**CITY OF TEMPE
DEVELOPMENT REVIEW COMMISSION**

Meeting Date: 08/09/2016
Agenda Item: 5

ACTION: Request for a Development Plan Review consisting of a new three-level parking structure for 1515 PARKING GARAGE, located at 1515 West 14th Street. The applicant is Gammage & Burnham P.L.C.

DEVELOPMENT PROJECT FILE
for
1515 PARKING GARAGE
(PL160233)

LA-101

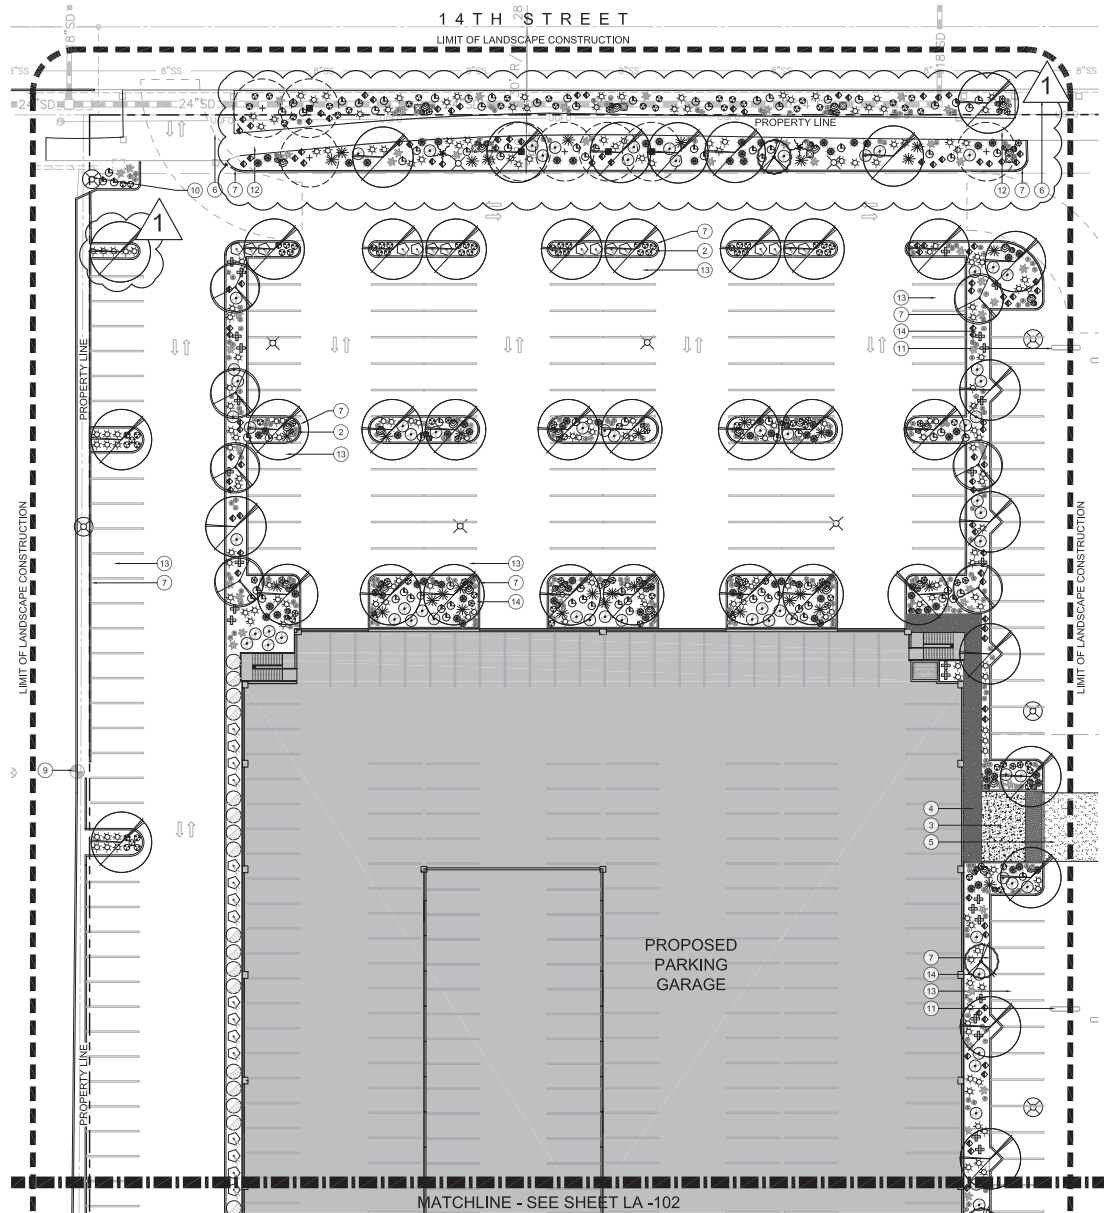
- Correctly indicate clear vision triangles at both driveways on the site and landscape plans. Identify speed limits for adjacent streets at the site frontages. Begin sight triangle in driveways at point 15'-0" in back of face of curb. Consult Intersection Sight Distance memo, available from Traffic Engineering if needed www.tempe.gov/index.aspx?page=801 . Do not locate site furnishings, screen walls or other visual obstructions over 2'-0" tall (except canopy trees are allowed) within each clear vision triangle.
